Addendum #1

RFP #CC621-26

CAMPUS BLOCK WALLS

Photo of Additional Alternative wall that is approximately 83'x 2'

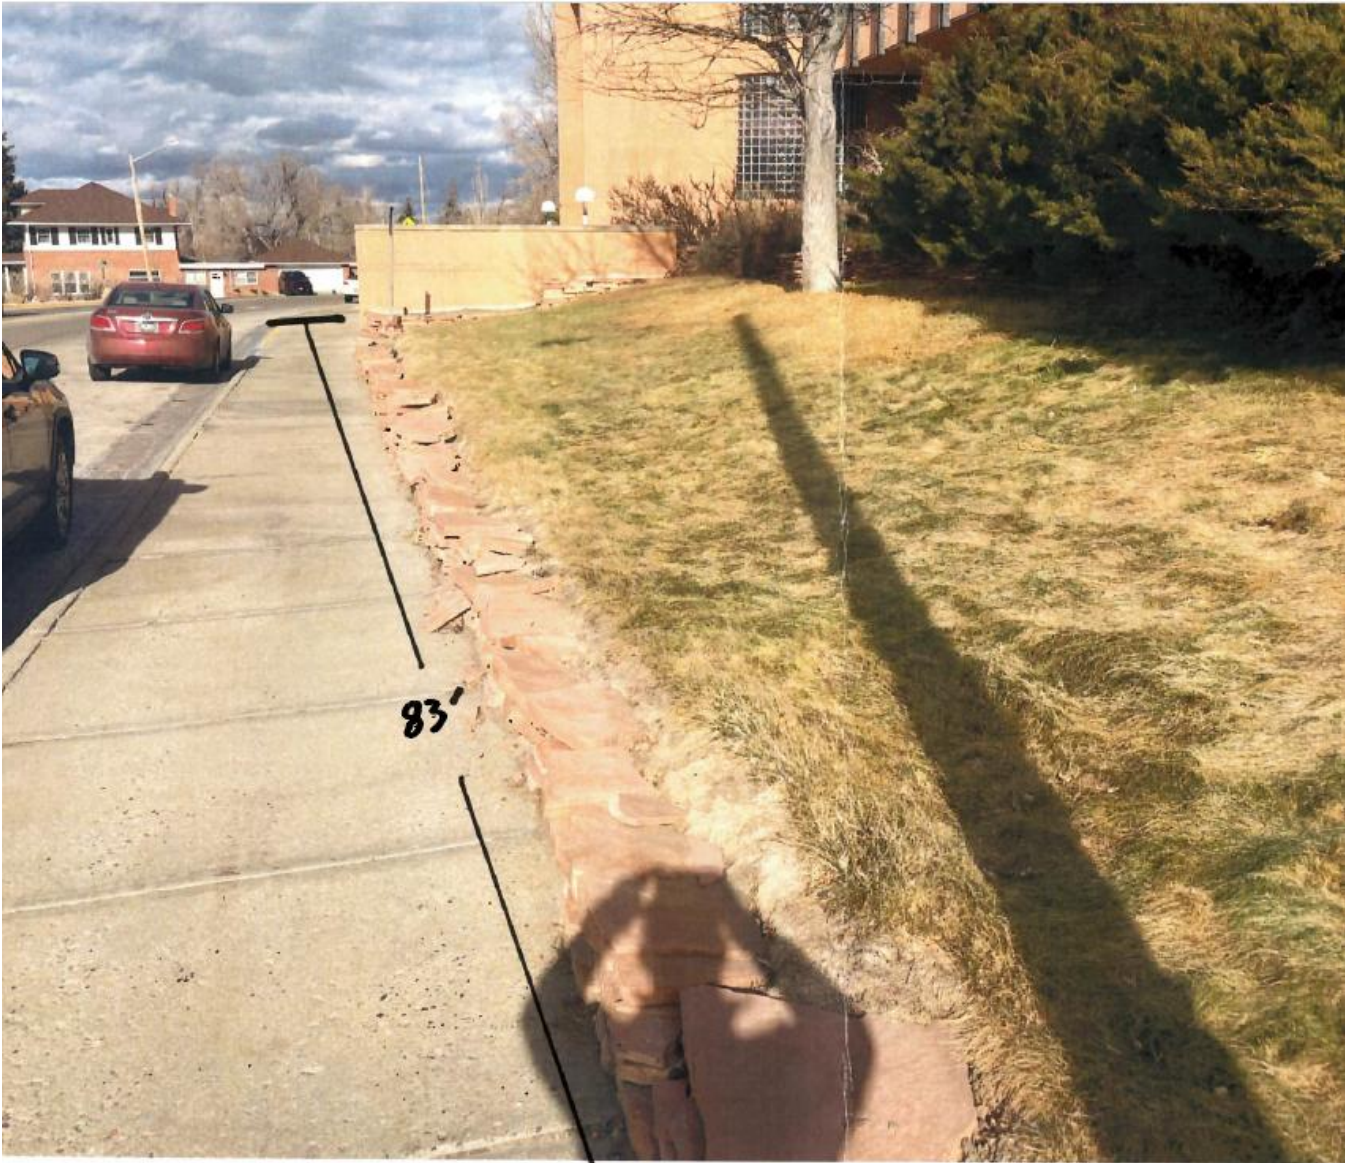
Is the short 2' section of wall supposed to be quoted separately or added to the total bid?

- There is an Additional Alternative #1 added to the bid sheet (page 3 of Addendum #1)
- This walls is approximately 83' long by 2' tall (see photo page 2 of Addendum #1)
